CORRESPONDENCE/MEMORANDUM
DISTRICT #6

Date: July 16, 1998
To: File
From: Randy W. Luedtke, P.E.
District #6 Pavement Design Engineer
Subject: **PAVEMENT DESIGN REPORT**
Approval Letter

Project I.D. 8600-02-01
Chippewa Falls - Cornell Road
Jim Falls - CTH R
STH 178
Chippewa County

Subject: Pavement Documentation -**REVISED**
Project ID 8600-02-01
Chippewa Falls - Cornell
Jim Falls - CTH R
STH 178
Chippewa County

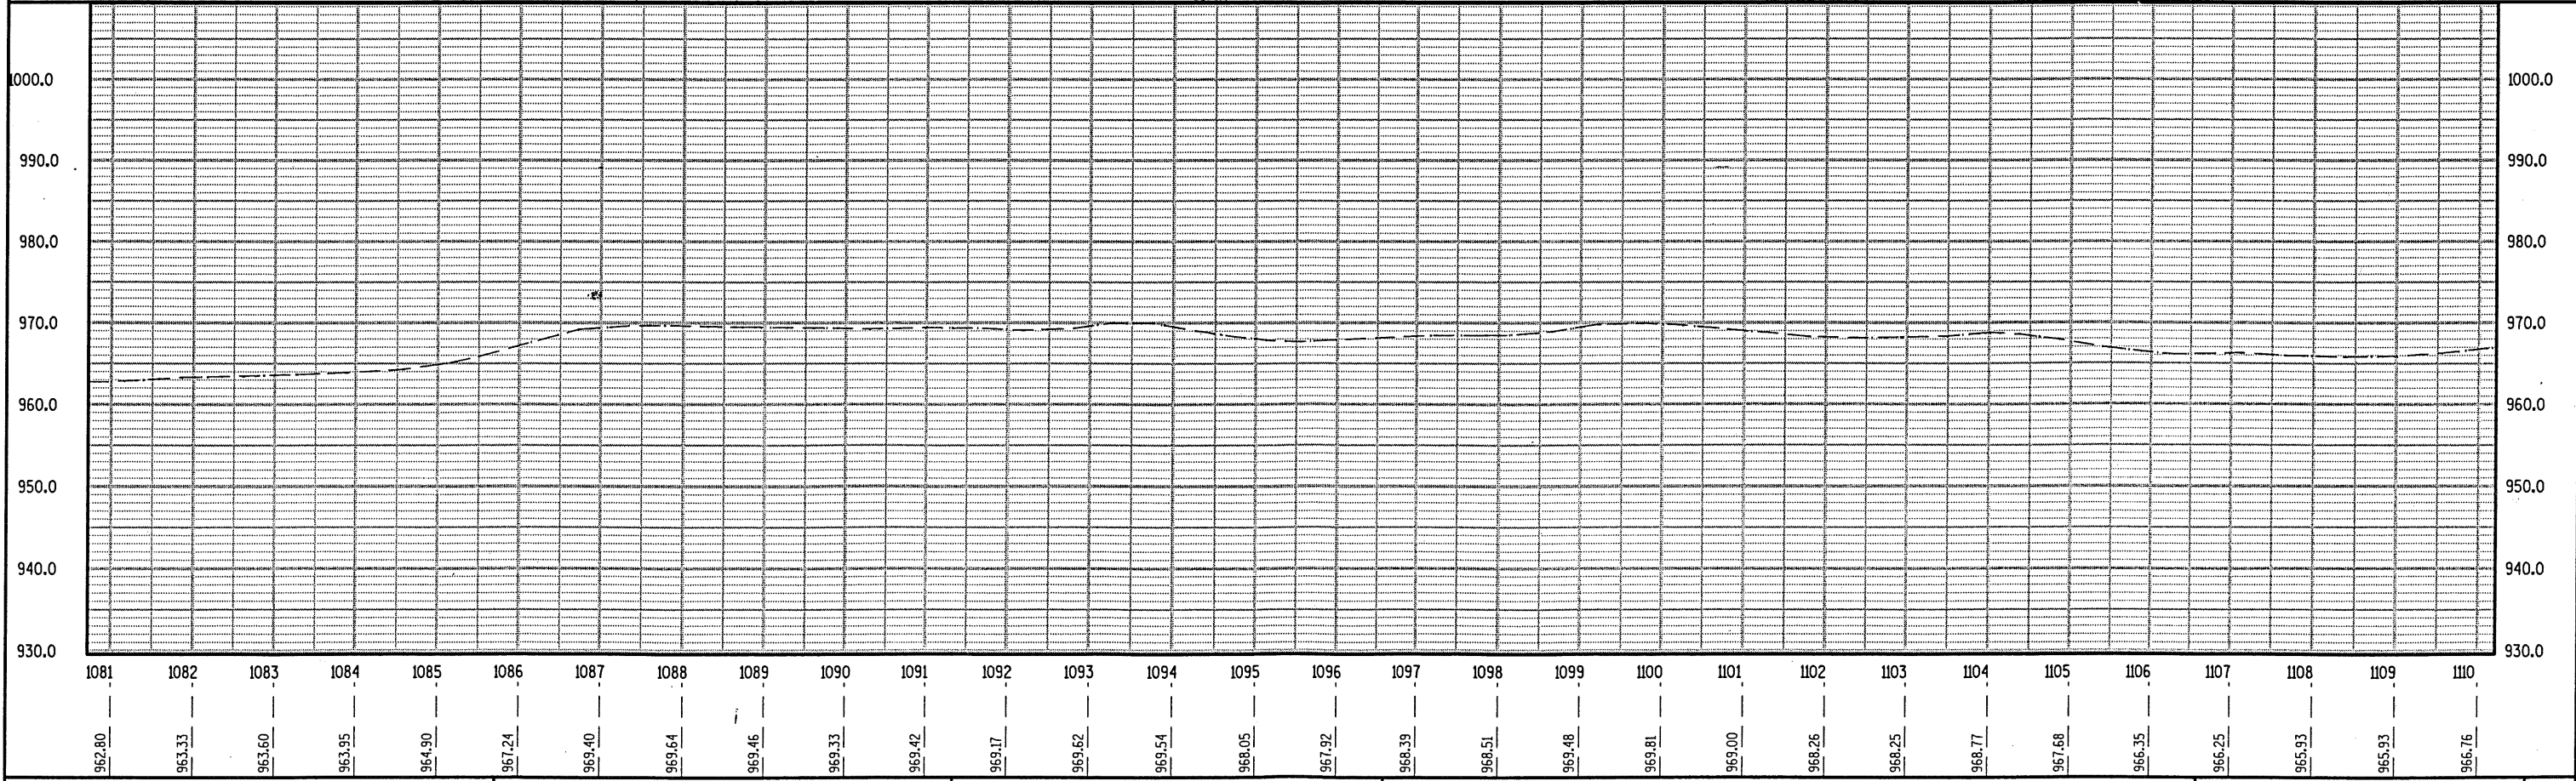
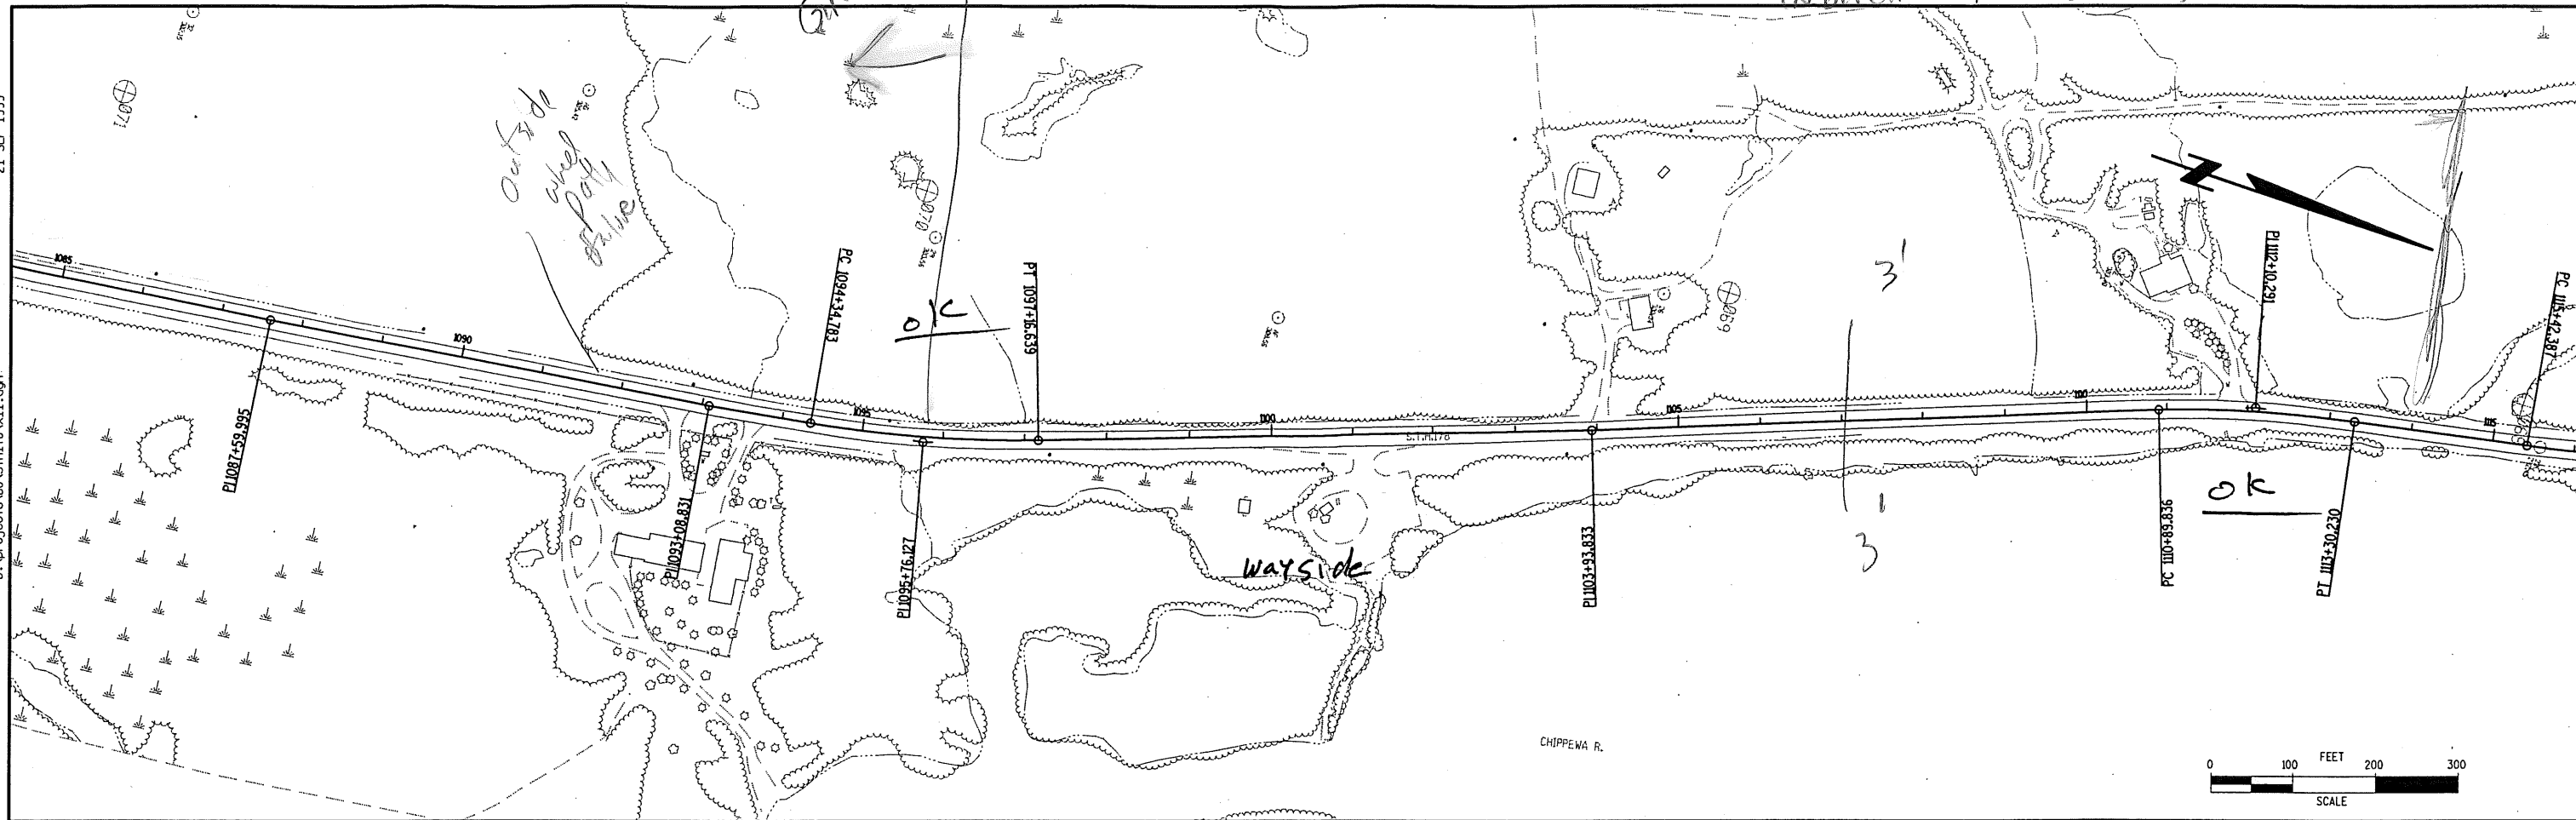
GRID 12/15

PRICE OUT
BREAKER RUN
DITCH MOUNTABLE CURB

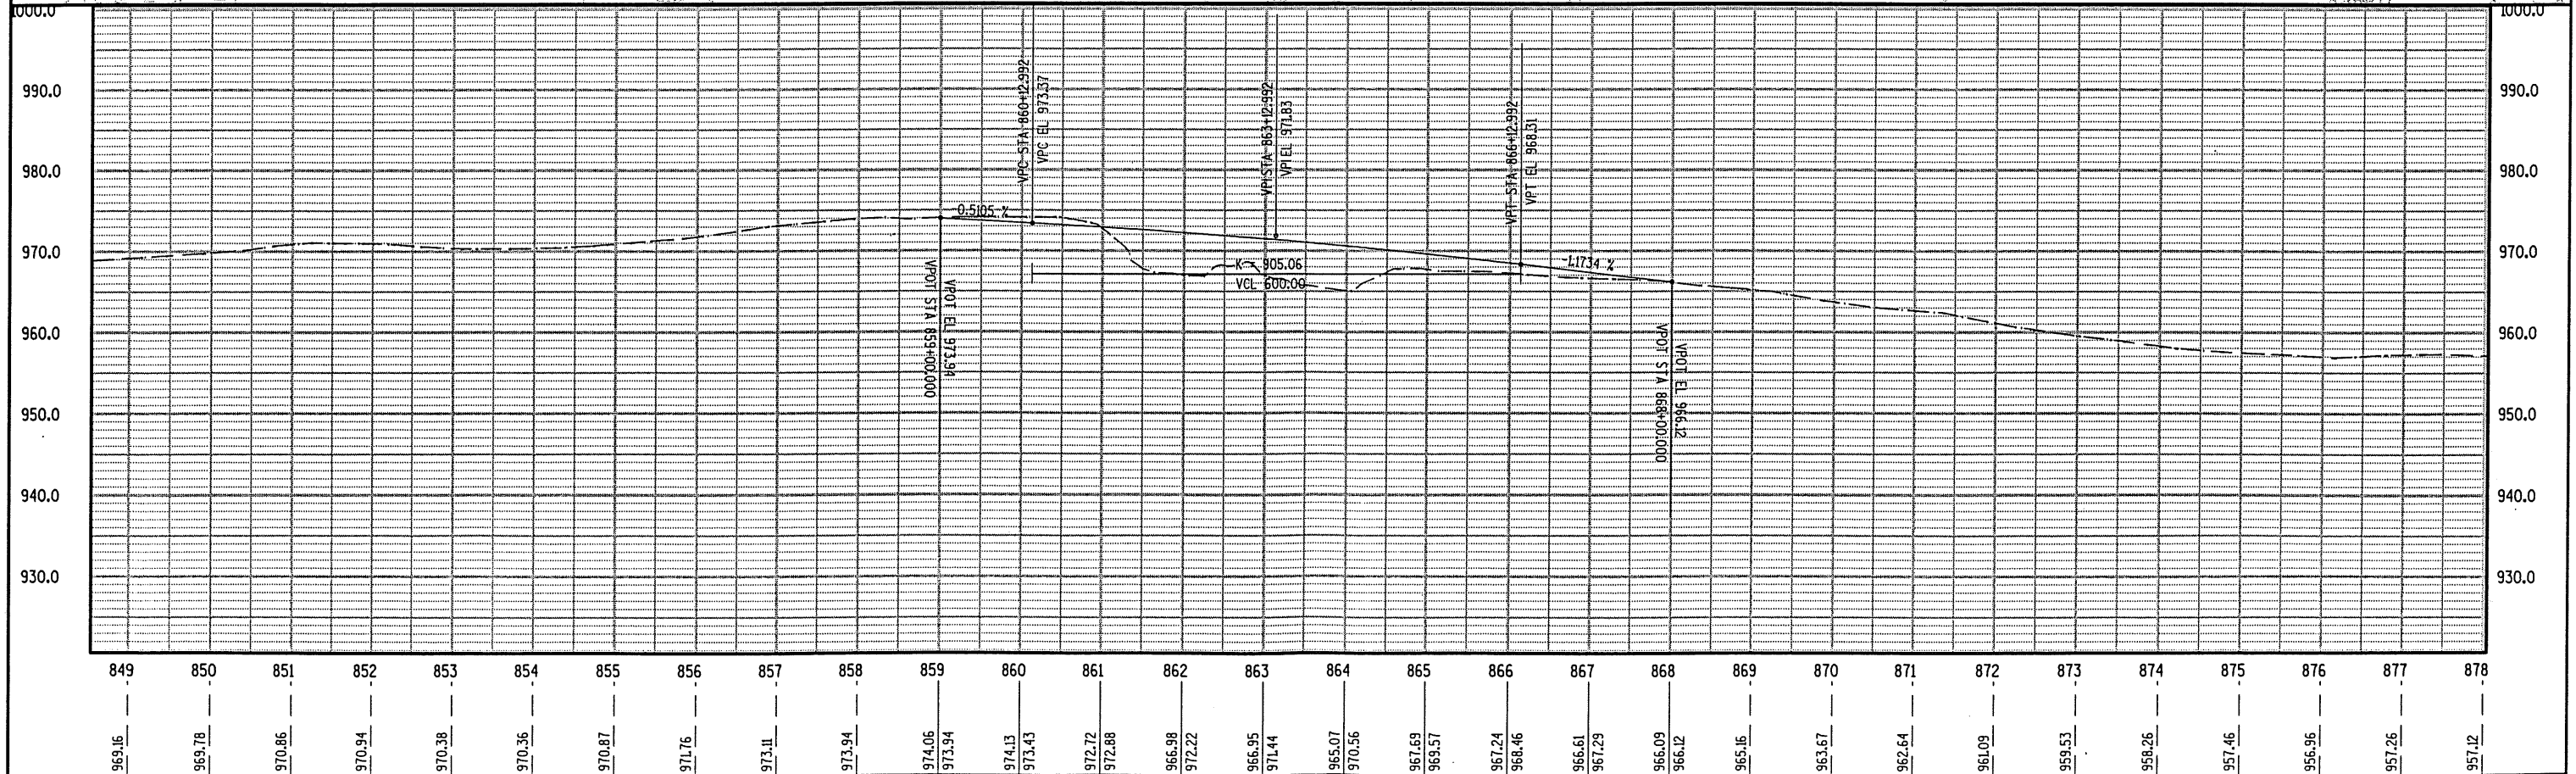
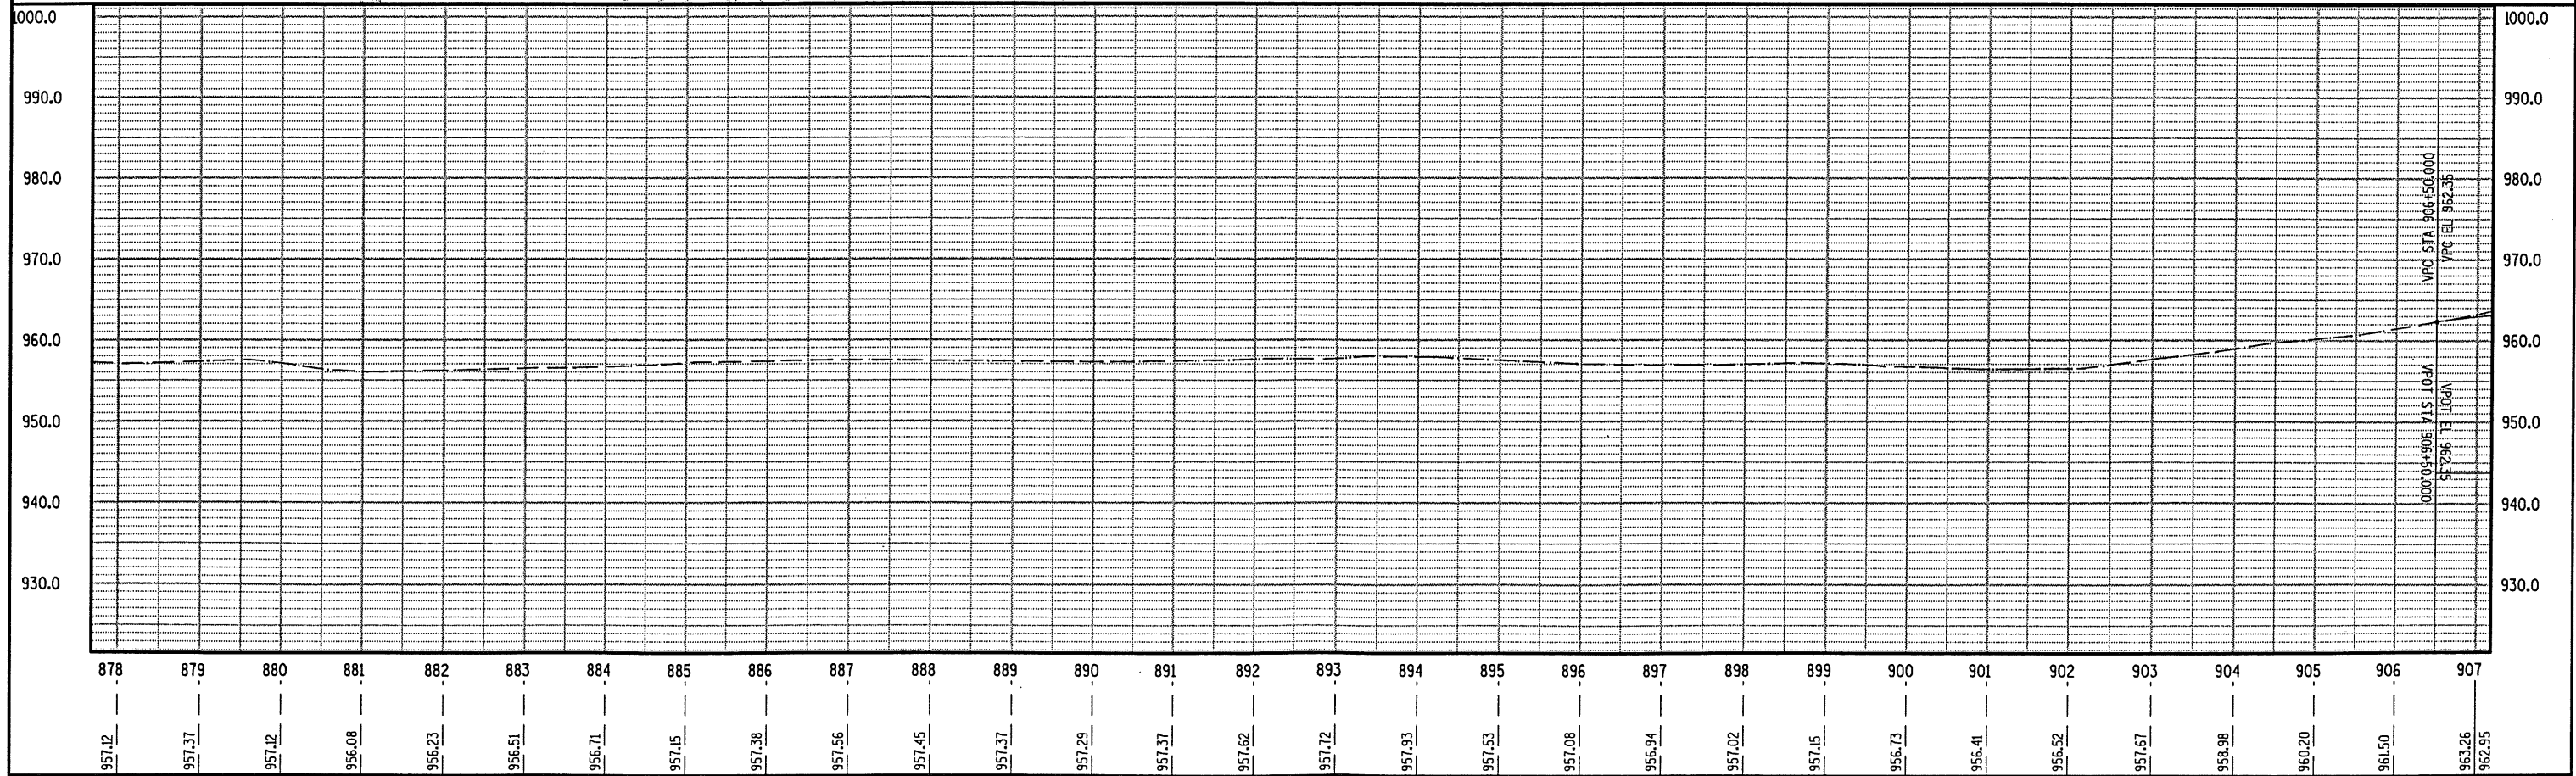
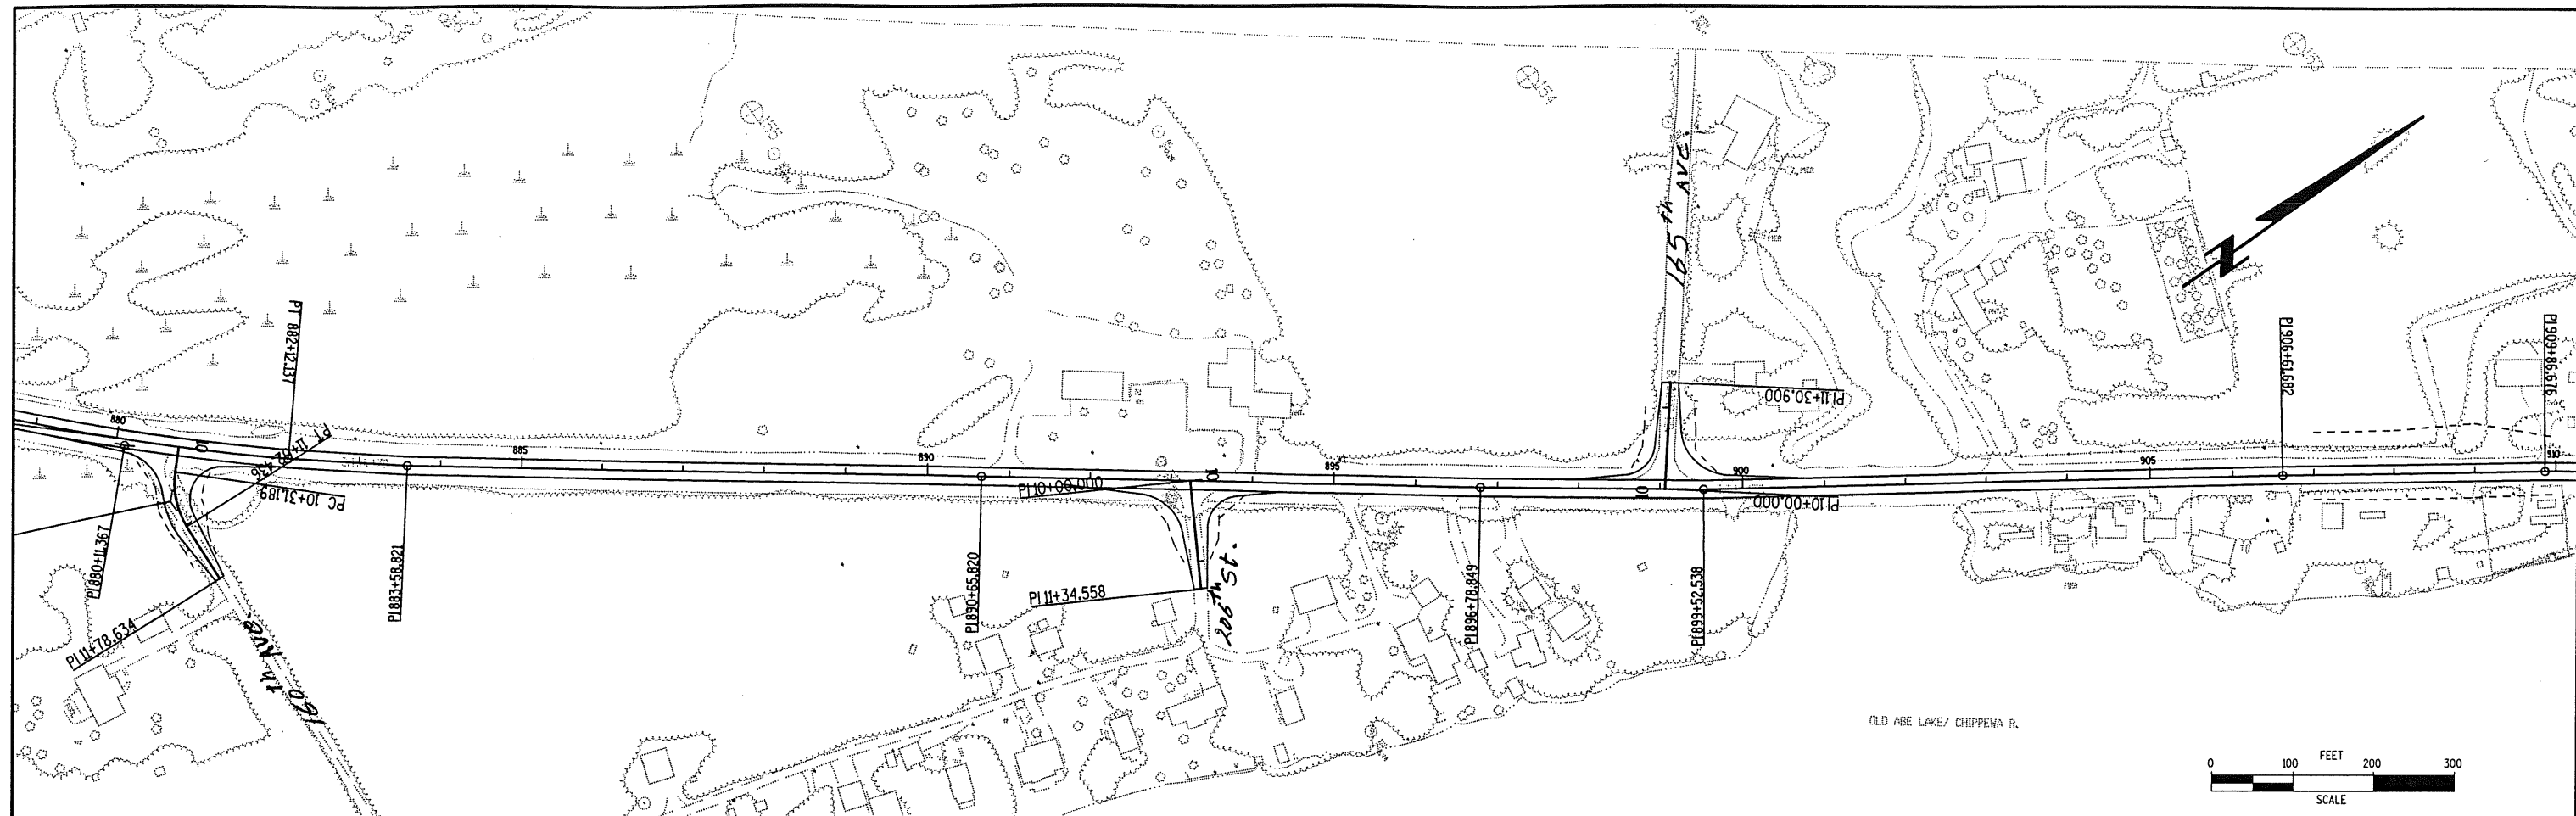
NOTE: THESE LOCATIONS WERE BASED
 ON MEMORY OF FIELD REVIEW 1999.
